Form 3160-5
(June 2019)UNITED STATES
DEPARTMENT OF THE INTERIOR
BUREAU OF LAND MANAGEMENTFORM APPROVED
OMB No. 1004-0137
Expires: October 31, 2021**SUNDRY NOTICES AND REPORTS ON WELLS**
Do not use this form for proposals to drill or to re-enter an abandoned well. Use Form 3160-3 (APD) for such proposals.5. Lease Serial No. **NMSF078769**

LOGOS Operating LLC, request a change in plans below:

WELL LOCATION AND ACREAGE DEDICATION PLAT

LOGOS Operating, LLC Operations Plan

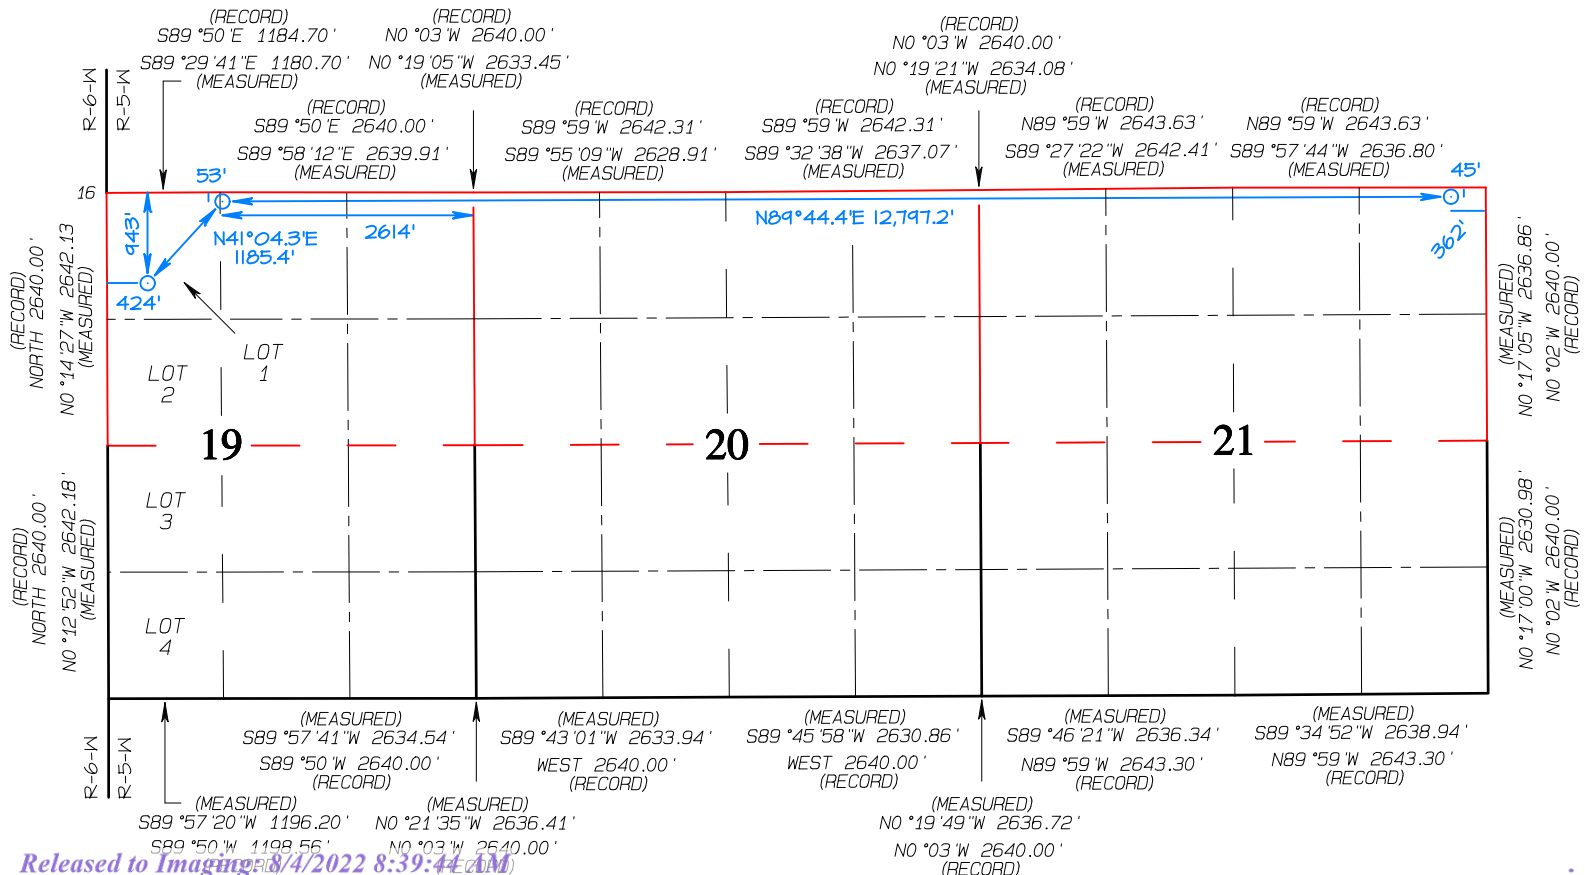
Original bottom-hole location from 52' FNL & 2320' FWL to **new bottom-hole location 45' FNL & 362' FEL**Original TD @ 17,598' MD 6965' TVD to **new TD @ 20,177 MD 6968' TVD**

LAST TAKE POINT
45' FNL 362' FEL
SECTION 21, T31N, R5W
LAT: 36.892172°N
LONG: 107.359288°W
DATUM: NAD1927

Plan: Plan #5 (Rosa Unit 645H/OH)

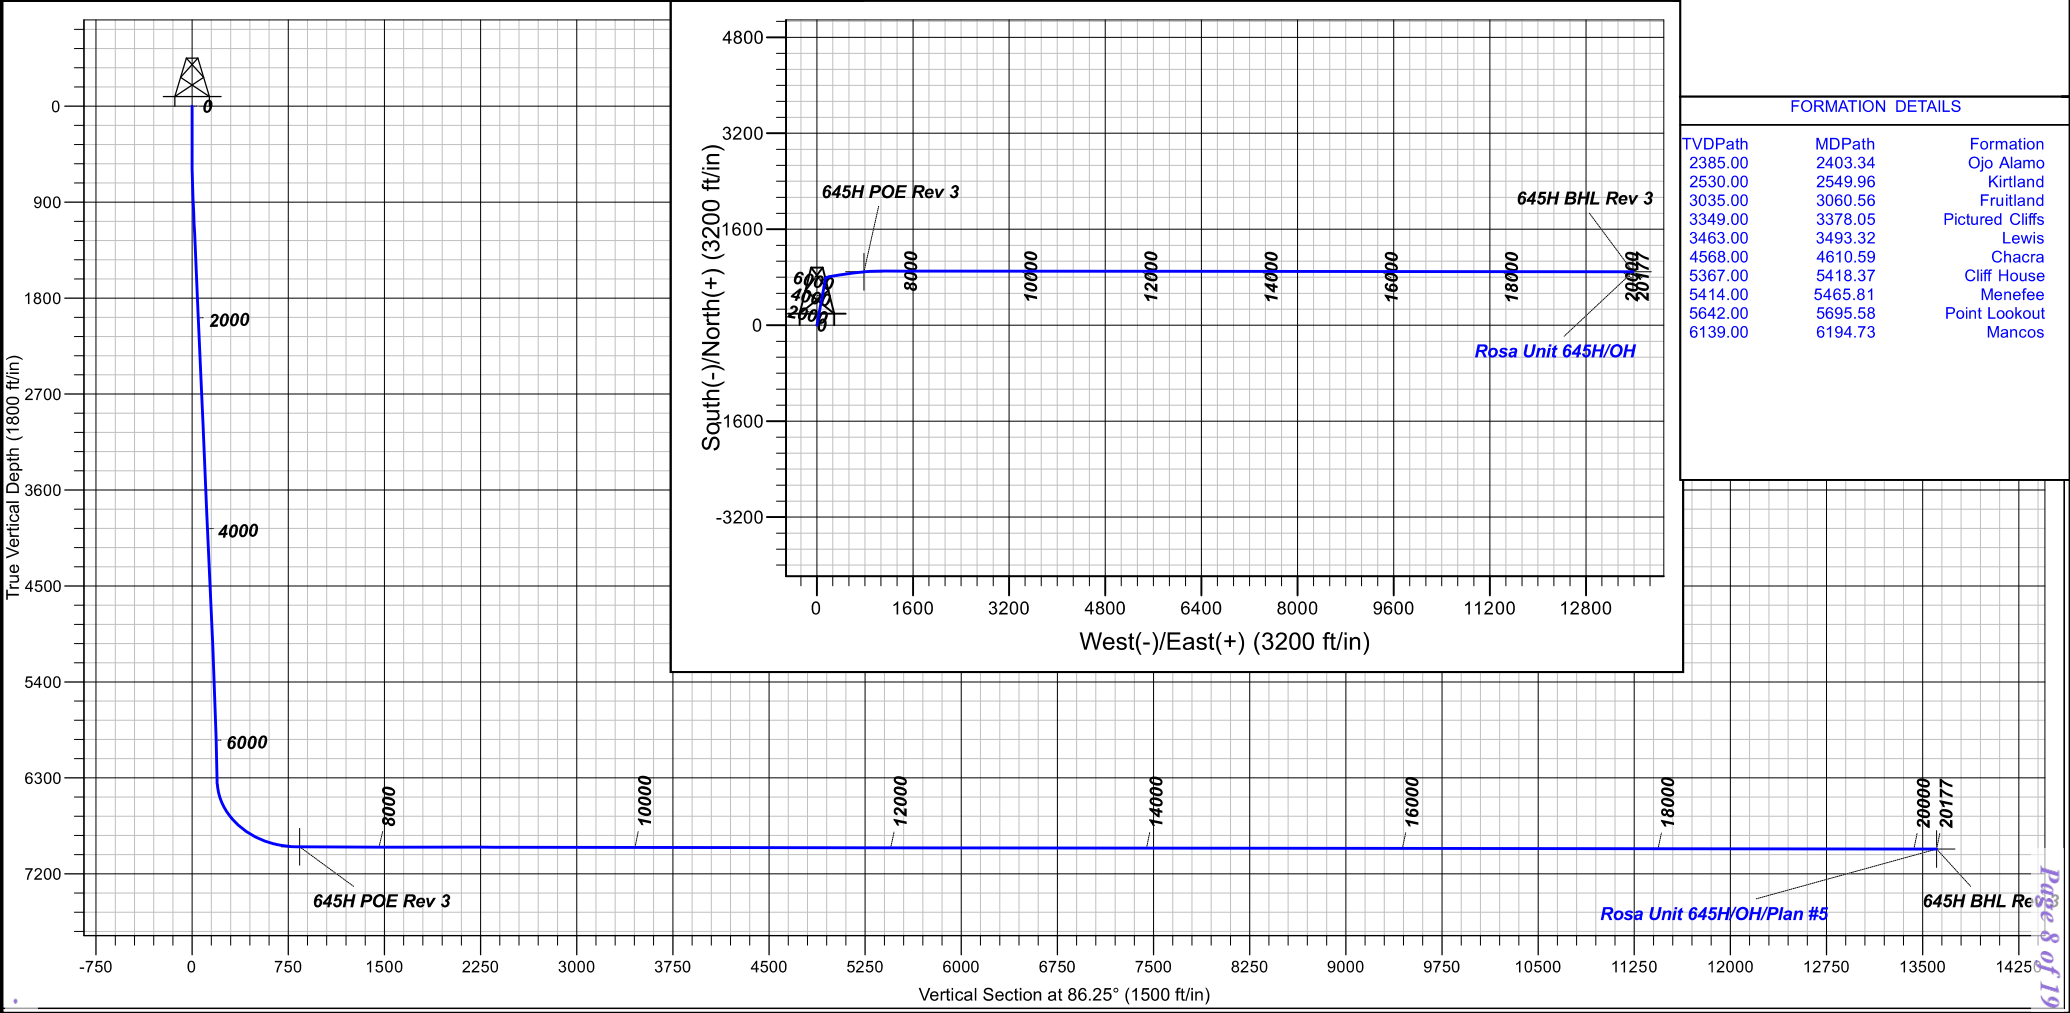
Original KOP @ 6406' MD 6348' TVD to **new KOP @ 6385' MD 6329' TVD**Original Landing Point @ 7398' MD 6970' TVD to **new Landing Point @ 7380' MD 6947' TVD**Original Intermediate casing 9.625" set depth @ 6268' MD 6211' TVD to **new casing depth 6270' MD 6211' TVD**Original Production casing 5.5" set depth @ 17,598' MD 6965' TVD to **new casing depth @ 20,177' MD 6968' TVD**

Name	TVD	+N/-S	+E/-W	Northing	Easting	Latitude	Longitude
645H POE Rev 3	6947.00	890.20	782.80	2144363.86	2848739.35	36.8921847	-107.4036521
645H BHL Rev 3	6968.00	891.05	13580.00	2144421.97	2861536.39	36.8921780	-107.3598900
